# RENESAS TECHNICAL UPDATE

Product Category	MPU/MCU		Document No.	TN-RH8-B0111D/E	Rev.	4.00
Title	Errata of RH850/E1x User's Manual Hardware Rev.1.20		Information Category	Technical Notification		
Applicable Product	RH850/E1x-FCC1 RH850/E1M-S RH850/E1L	Lot No.	Reference Document	Refer to the below		
		-

Errata of RH850/E1x User's Manual Hardware Rev.1.20

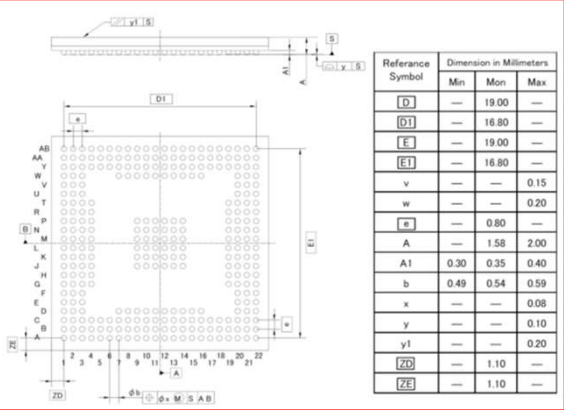
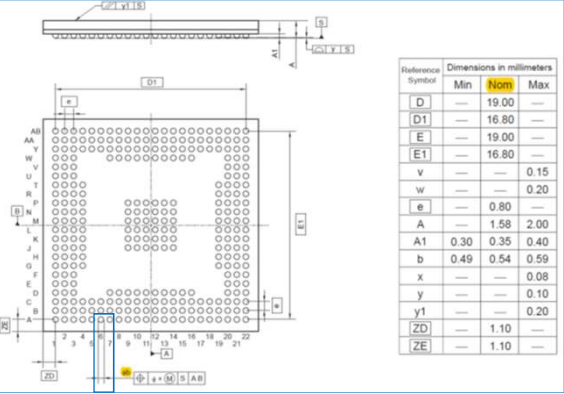
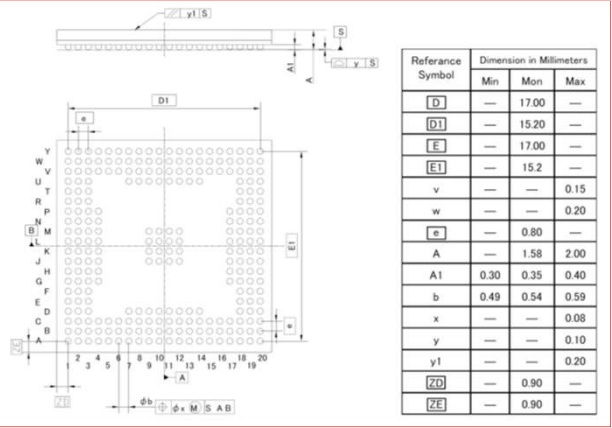
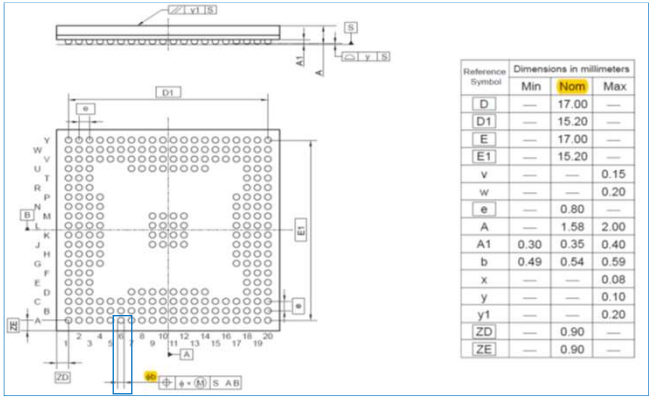
46	E1L only (UM P2262)	Electrical Characteristics	37.3.6 CSIH Timing Note.	● n = 0 to 2, x = 0 to 5 (n = 0), x = 0 to 3 (n = 1, 2, 3)		● n = 0 to 2, x = 0 to 5 (n = 0), x = 0 to 3 (n = 1, 2)		Writing Error	Reported on TECHNICAL UPDATE "TN-RH8-B111C/E".		-	-	2262
47	2645	Electrical Characteristics	Table 37.37 ADC Converter Characteristics (Depending on the product, table number is different.)	A/D conversion time (FOP = 20 MHz, 40 MHz)		A/D conversion time		Writing Error	Reported on TECHNICAL UPDATE "TN-RH8-B111C/E".		2645	2604	2277
48	2853, etc.	Appendix Package Dimensions	Appendix Package Dimensions	Refer to "Package Dimensions (BGA)" sheet.		Refer to "Package Dimensions (BGA)" sheet.		Writing Error	Reported on TECHNICAL UPDATE "TN-RH8-B111C/E".		2853, 2854	2812, 2813	2451

No.56\_Figure 16.5

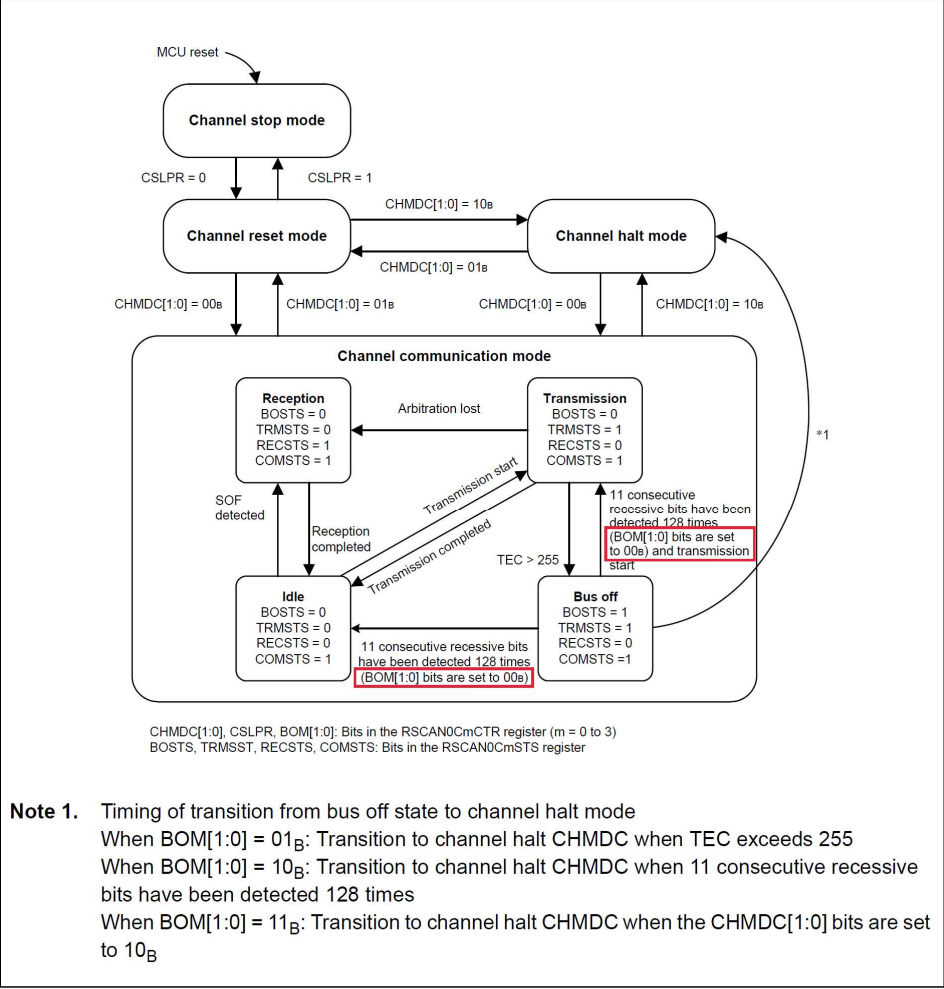
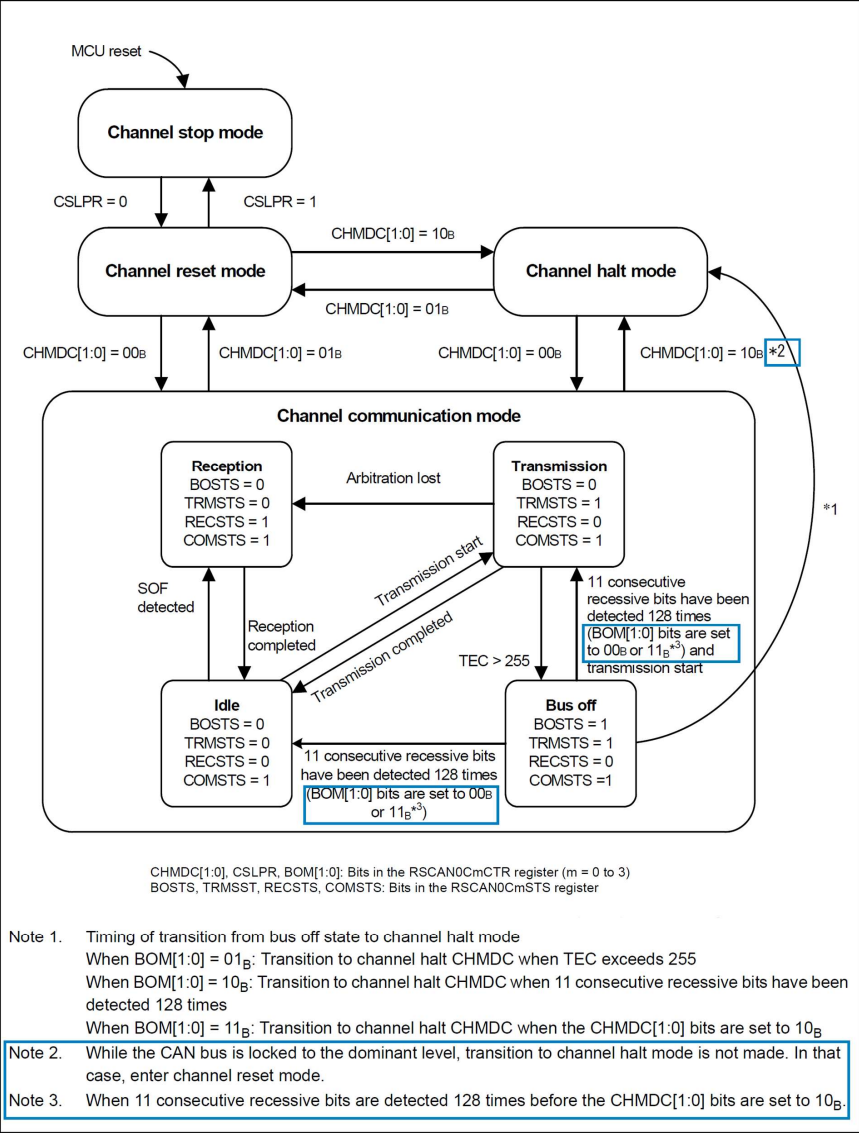
53	298	CPU System	(4) MPTRGN - MPU end region register @PCU	bit-map 4-0: MPTRGN Table 3.119 MPTRGN Register Contents Bit Position: 31 to 5 4 to 0 MPTRGN	bit-map 3-0: MPTRGN Table 3.119 MPTRGN Register Contents Bit Position: 31 to 4 3 to 0 MPTRGN	Writing Error	Reported on TECHNICAL UPDATE "TN-RH8-B111C/E".	Modified the section title of No. 13.	298	260	253
54	582	CSIH	13.5.10 CSIH interrupt requests (3) INT_CSHTIC (communication status interrupt) Figure 13.25 Generation of INT_CSHTIC in Job Mode			Writing Error	Reported on TECHNICAL UPDATE "TN-RH8-B111C/E".		582	543	534
55	583	CSIH	13.5.10 CSIH interrupt requests (3) INT_CSHTIC (communication status interrupt) Table 13.10 Generation of INT_CSHTIC in Job Mode		The left descriptions marked in red are deleted. 	Writing Error	Reported on TECHNICAL UPDATE "TN-RH8-B111C/E".		583	544	535
56	860	RS-CAN	16.4.2.6 Channel Modes Figure 16.5 Channel Mode State Transition Chart	Refer to "No.56, Figure 16.5" Sheet.	Refer to "No.56, Figure 16.5" Sheet.	Additional Description	Reported on TECHNICAL UPDATE "TN-RH8-B111C/E".		860	821	812
